# City of Santa Fe, New Mexico

# memo

**2024-009478-HDRB, 614 Paseo de Peralta, Downtown & Eastside Historic District, Contributing,** Stefanie Beninato, agent for Miriam Leth Espensen, owner, proposes to construct a 5'-8" high coyote fence with pedestrian gates where the maximum allowable height is 4'-6". Exceptions are requested to 14-5.2(D)(9) to exceed the maximum allowable height.

Figure 2: Photo from the 1985 HCPI

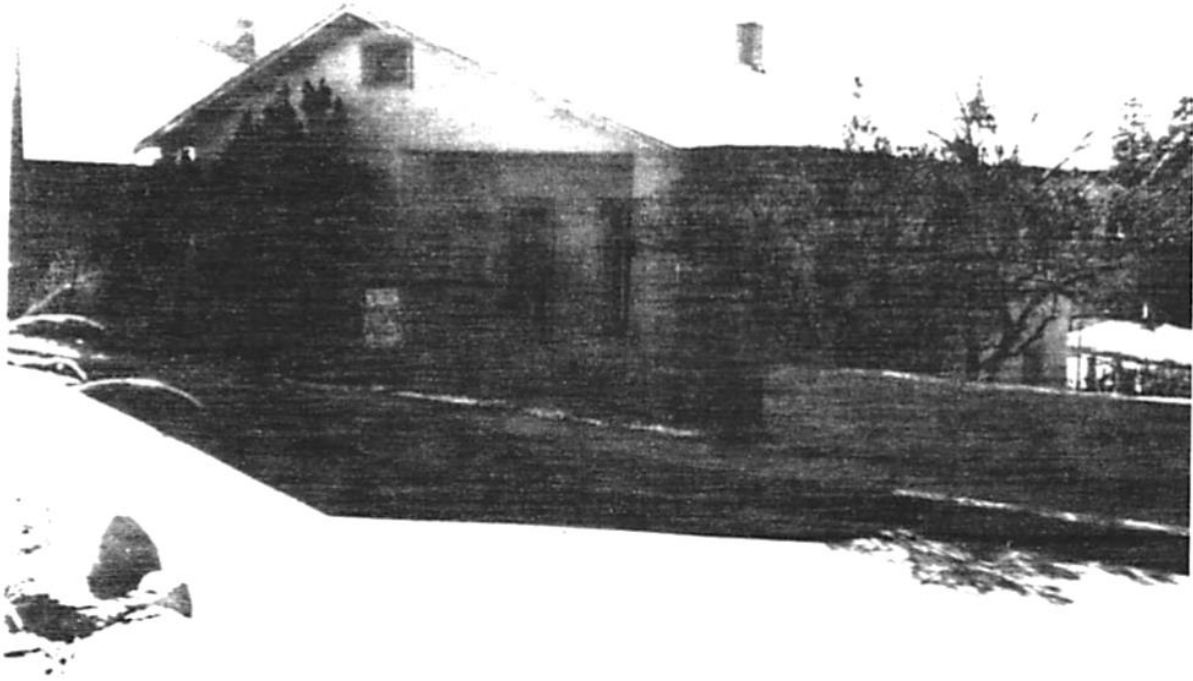
A photograph from the 1985 HCPI (See Figure 2) illustrates that this house, like others in the streetscape, had low transparent fencing at the property line. Although it is difficult to discern the exact fence material, it is clear that historically the house had a direct relationship with the street as do other historic buildings in the streetscape.

Figure 3: Streetview looking west

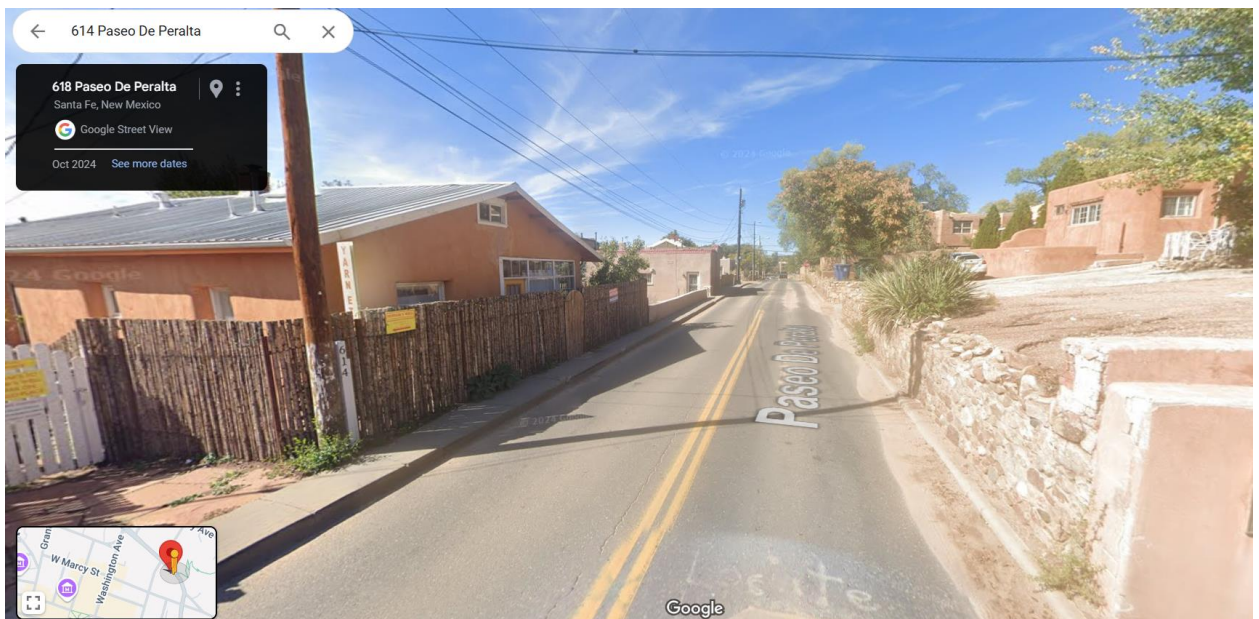
Staff Response: Staff does not agree with this statement. The coyote fence as proposed damages the character of the district, is a violation so the streetscape standards and the underlying BCDMAR zoning standards. The heights of the walls and fences along this streetscape of Paseo de Peralta range in height from 24” (2’-0”) and 108” (9’-0”) and the walls and fences vary from retaining walls constructed of rock or stuccoed concrete masonry on the north side of the street. The tallest wall is a retaining wall with yard wall on top. The combination of a yard wall with retaining wall is allowed at a height greater than properties with no retaining wall. There is a grade change between the properties on the south side of the street and those on the north side. Retaining walls characterize the streetscape on the north side, with additional walls that are substantially set back from the plane of the retaining walls. The south side of the street is lined with lower yard walls and fences with stepped heights or wrought iron creating an open fenestration of the yard wall, two picket fences, one wire fence, and at the edge of the streetscape there is a single coyote fence located on the Girls, Inc. Property. The Girls, Inc property is part of the Hillside streetscape rather than the Paseo de Peralta streetscape, and is visually disrupted from the property, as it is located around the curve from the subject property. Furthermore, the Girls, Inc. property is part of a different zone district than the subject streetscape.

Streetview images have been provided to illustrate the streetscape and context of yard walls and/or fences in the streetscape.
